विषय:- जनपद देहरादून में प्रधानमंत्री ग्राम सड़क योजना के अन्तर्गत पुरकुल गांव से भीतरली किमाडी मोटर मार्ग (कुल लम्बाई-10.400 किमी०) के नव निर्माण हेतु 3.528 है० वन भूमि का गैर वानिकी कार्य हेतु वन संरक्षण अधिनियम 1980 के अन्तर्गत पी०एम०जी०एस०वाई० सिंचाई खण्ड को हस्तान्तरण प्रस्ताव। (FP/UK/ROAD/20710/2016)

जनपद देहरादून में प्रधानमंत्री ग्राम सड़क योजना के अन्तर्गत प्रस्तावित पुरुकुल गांव से भितरली-किमाड़ी मोटर मार्ग (लम्बाई 10.40 कि०मी०) के प्रथम स्टेज का नव निर्माण किया जाना प्रस्तावित है। उक्त मार्ग का वन भूमि ((3.528 हे०) का वन भूमि प्रस्ताव-FP/UK/ROAD/20710/2016 है।

Geological Assessment of the alignment corridor proposed for the construction of 10.40 km long motor road joining village Purkul to Bhirtali-Kimadi motor road, in Sahaspur block, distt. Dehradun.

Digital map of the proposed alignment of village Purkul to Bitharli-Kimadi motor road, distt. Dehradun

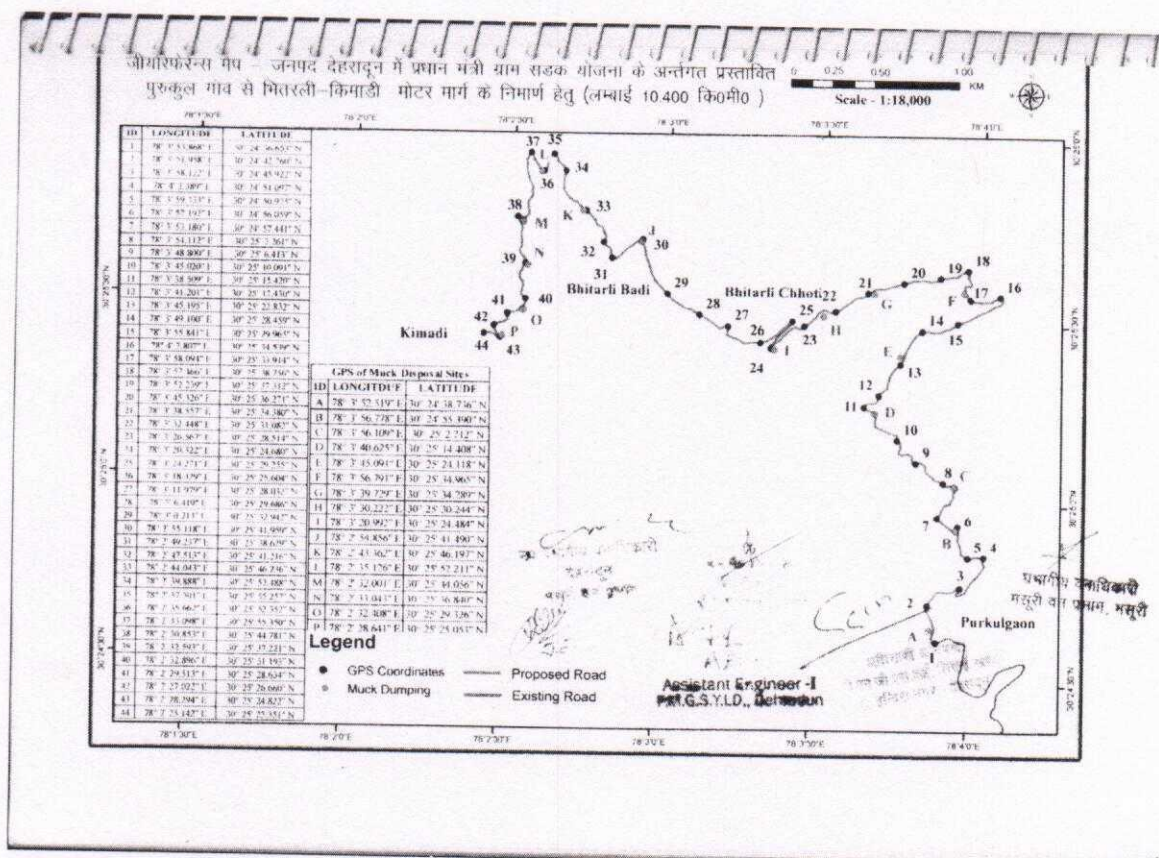
Due to the existing narrow jeep road(point no. 25 in digital map shown below) and a stretch of steep hill slope(point no. 11), the alignment 1 was questioned by the "Department of Forest and Climate Change" Therefore, on the request made by Er. Sanjay Singh, Executive Engineer, I carried out the geological assessment of the whole alignment with special focus on the "questioned stretch" of the alignment on 30.01.2020 in the presence of Er. S.B Lingwal, Assistant Engineer and Er. Vikas Barthwal, Junior Engineer, PMGSY, Irrigation Division, Dehradun.

2- Location:- The proposed 10.40 km long alignment corridor originating from km 6 of Malsi-Purkul motor road in the upslope direction comprising 5 HP bends following the upslope of the high gradient jeep road, in Sahaspur block, distt. Dehradun. The alignment stretch in questioned is the point no. 11 and 25 as shown in the digital map (explained in details below).

At the point no. 11 as per digital map, there is a small slip zone which activated recently before 2-3 years forming 2 chute. Prima Facie, it seems to be activated due to the continuous hydraulic impact at the toe of the hill slope as the gadera bears the sinuous course with left bank as the cut-off side and right bank as slip-off side. The stretch of 40-50 m near point no.11 passes across this steep slope have extensive seepage with fractured bedrock underneath. Therefore, toe protection is essential to avoid any toe erosion and facilitate sliding in future.

At the point no. 25, there is an existing jeep road but have gradient of 1:6 to 1:12 which is extremely high in comparison to the proposed gradient of 1:24 to 1:20. Also, the current jeep road passes across a slide zone which may become huge post toe-cutting. Therefore, the proposed alignment passing above the crown of the active slide zone.

1. Across the steep slope, i.e near point no. 11 in digital map, the construction for 50 m stretch of road should be carried out by half cut and half fill method with ascent upward. The extensive seepage will reduce the intergranular shearing strength and may facilitate sliding. Therefore, the slope with basement for gabion wall should be strength by deeply anchored soil nailing technique (for foundation) followed by shotcreting, so as to improve the ground characteristics and minimize the probability of any rock fall/sliding.

2. Due to the sinuous course of the gadera, Gabion wall in 2-3 step should be construct at the toe of the hill slope point no. 11 (in digital map) to avoid toe scouring/erosion by the huge discharge of gadera in monsoon.
